DRAINAGE INFORMATION SHEET

PROJECT TITLE: Asphalt Pavers, Inc. (GSL SAN MATEO S/B) ZONE ATLAS/DRNG. FILE #: L18/D 41

Re: Permit for Asphalt Paving of small parking area (999 Sq. Ft) south of the building at 636 San Mateo SE.

CONFERENCE RECAP

SUBJECT: 636 San Marco S.F. (Addition)

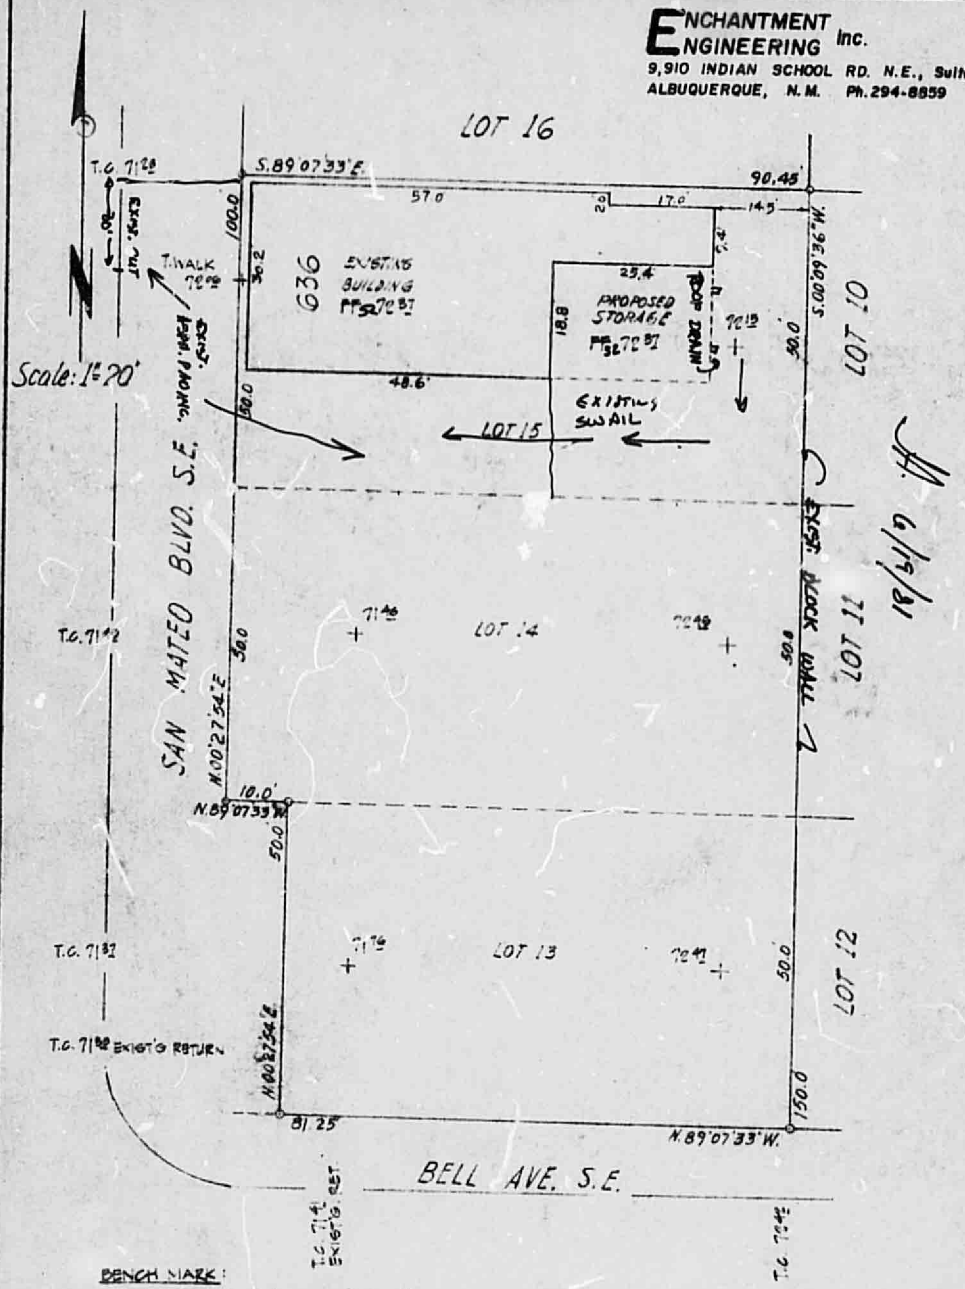
FINDINGS:
1. Finish Floor Elevation to M.S.L.
2. Couple of T.C. spot elevations
3. Also indicate existing grad. conditions for the proposed development
4. Existing drainage pattern before development and proposed confirmed by a few spot elevations.
5. Discuss offsite flows.

NOTE: Developed runoff must be routed to public-right-of-way. Otherwise let's discuss.
